POR SF U31
11.3.31.11 LUP Upland
T1 South
DEQ Conesp.

Subject: Marine Terminal 1 South
Response to Review Comments on Risk Assessment Work Plan
ECSI File No. 2042

The Port of Portland (Port) has prepared the following response to the Oregon Department of Environmental Quality (DEQ) review comments on the Marine Terminal 1 (T1) South Risk Assessment Work Plan, as documented in your letter dated October 25, 2001. The Port's response to DEQ's specific comments (in italics) are summarized below.

SITE PLAN - Preliminary Major Land Division

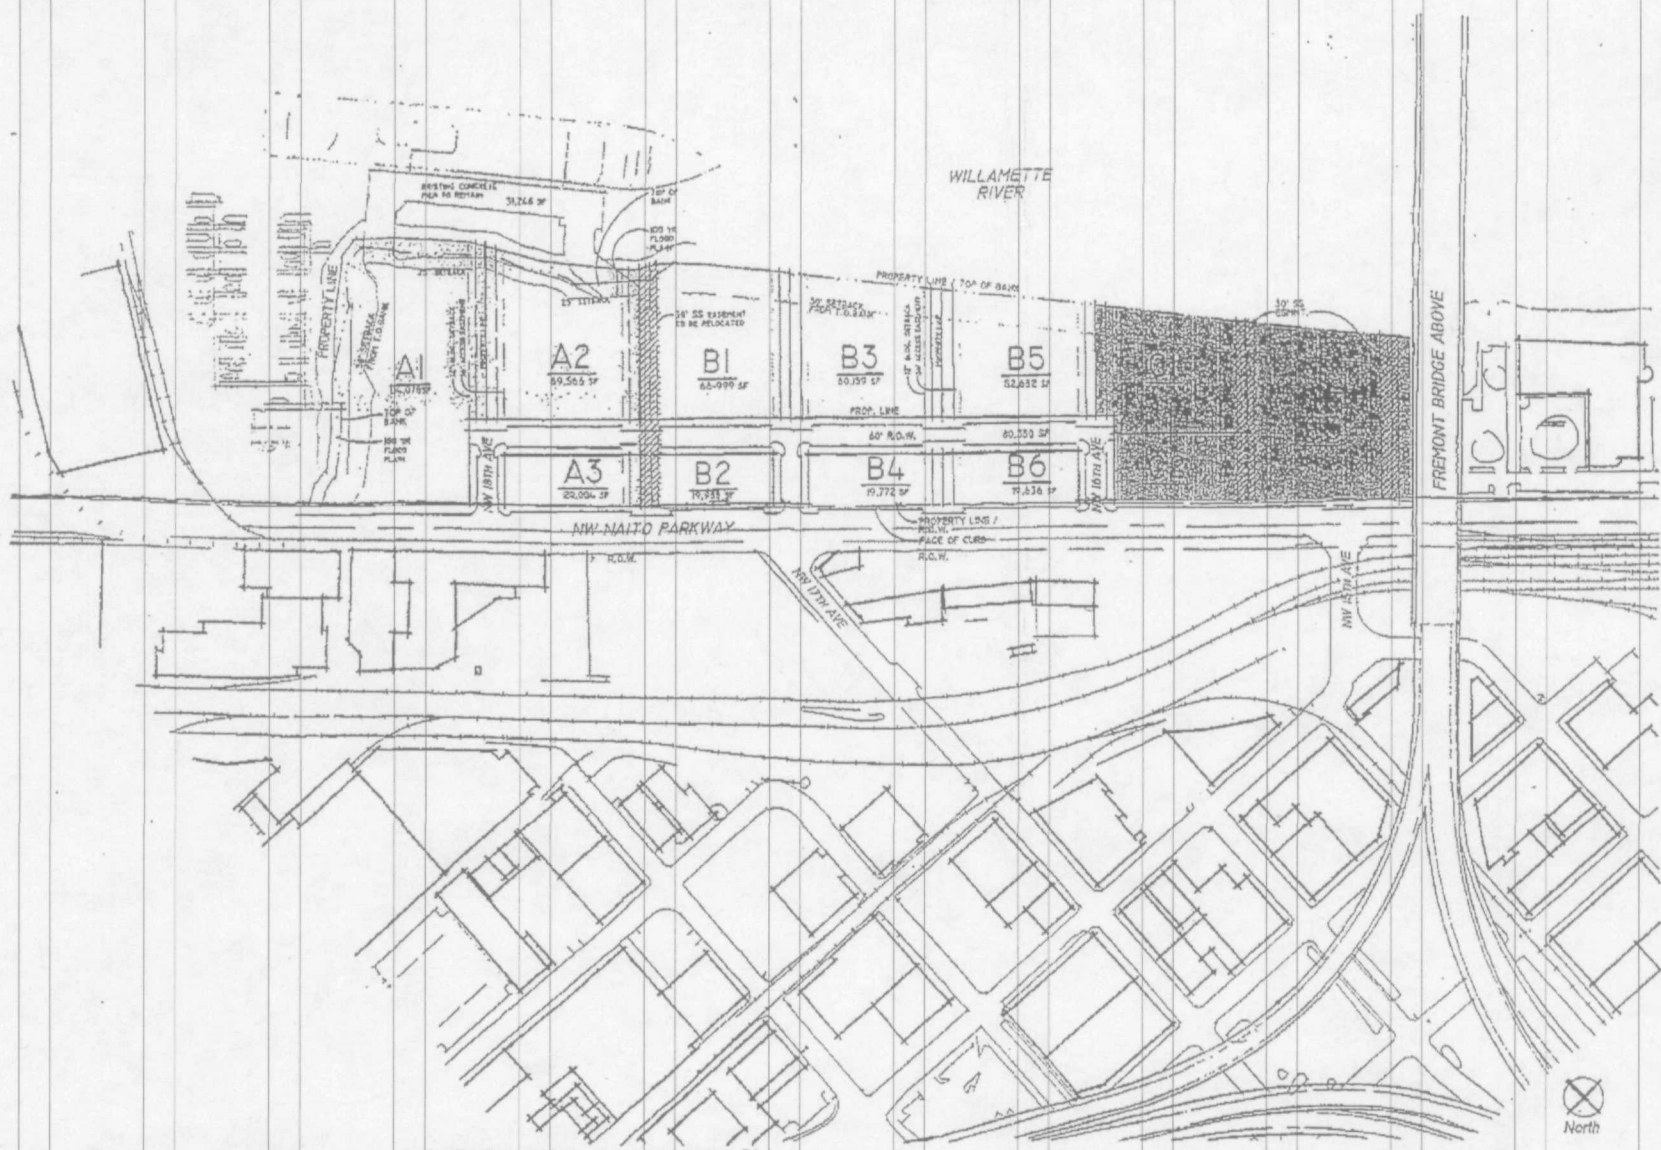
6) Page 9, Areas of Concern (AOC). *The basis for delineating the three AOCs should be explained. Exposure units (or areas of concern) should consider contaminant distribution and/or the future development of the site. The work plan indicates that the three exposure units are based on future development of the site, which is appropriate. However, supportive information needs to be provided to support the divisions. Present site development plans if available. If the three areas of concern are to be divided further by development, it may be appropriate to divide the site into more than three exposure units given the contaminant distribution.*

Response: The three areas of concern were selected for this site based on contaminant distribution, the areas of the site identified as having petroleum contaminated soils during the RI, and future development plans for the site. The areas of concern are presented in the work plan and cover all of the areas of contaminated soil identified in the RI. A preliminary major land division site plan is included as an attachment.
